**Report: PunchList**  
**Function: Test, Adjust, & Balance**  
**Date: 03/11/2026**  
**Completed By: National TAB**

## 03-09-26 Culvers - Brooklyn, OH

**Issue Name :** PRV-1 missing a backdraft damper  
**Description :** The backdraft damper was not found at the store. Recommend installing one and ensuring it fully opens to not impact airflow.  
**Created By :** National TAB                      **Assigned To :** National TAB - Brianna Biggs  
**Status :** Open  
**Priority :** Low                                      **Asset Tag :**  
**Originated Date :** 03/11/2026 - Aaron Cosby - National TAB

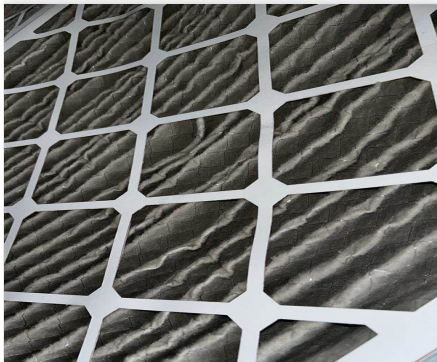
**Issue Name :** PRV-2 & PRV-3 missing grease cups  
**Description :** No grease cups found near units.  
**Created By :** National TAB                      **Assigned To :** National TAB - Brianna Biggs  
**Status :** Open  
**Priority :** Low                                      **Asset Tag :**  
**Originated Date :** 03/11/2026 - Aaron Cosby - National TAB

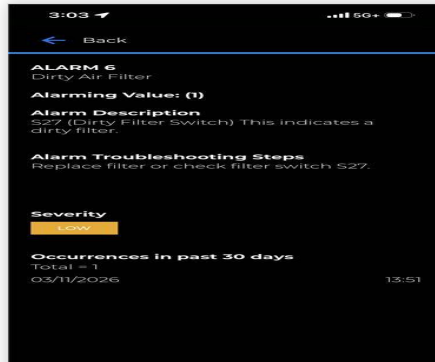
**Issue Name :** RTU-1 & RTU-2 dirty filters  
**Description :** Filters were not changed after construction. Recommend replacing (12x 24"X24"X2")  
**Created By :** National TAB                      **Assigned To :** National TAB - Brianna Biggs  
**Status :** Open  
**Priority :** Medium                                      **Asset Tag :**  
**Originated Date :** 03/11/2026 - Aaron Cosby - National TAB

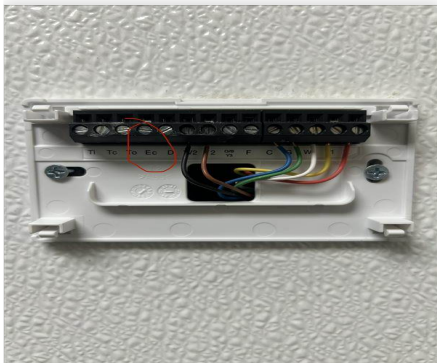
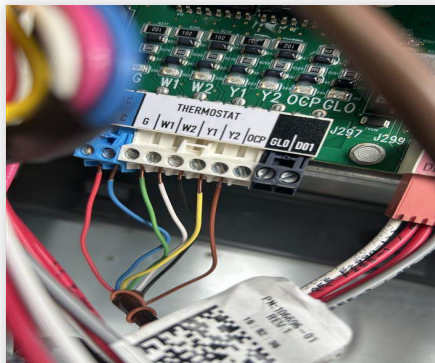
**Issue Name :** RTU-1 & RTU-2 missing occupancy wiring  
**Description :** Both RTUs need thermostat wire run from OCP on each RTU to their respective Ec terminal. Without it, economizing will be disrupted and Humiditrol reheat will not operate. This will cause negative building pressure and compromise the unit's ability to remove moisture from the air. A jumper was temporarily installed during balancing  
**Created By :** National TAB **Assigned To :** National TAB - Brianna Biggs  
**Status :** Open  
**Priority :** Medium **Asset Tag :**  
**Originated Date :** 03/11/2026 - Aaron Cosby - National TAB
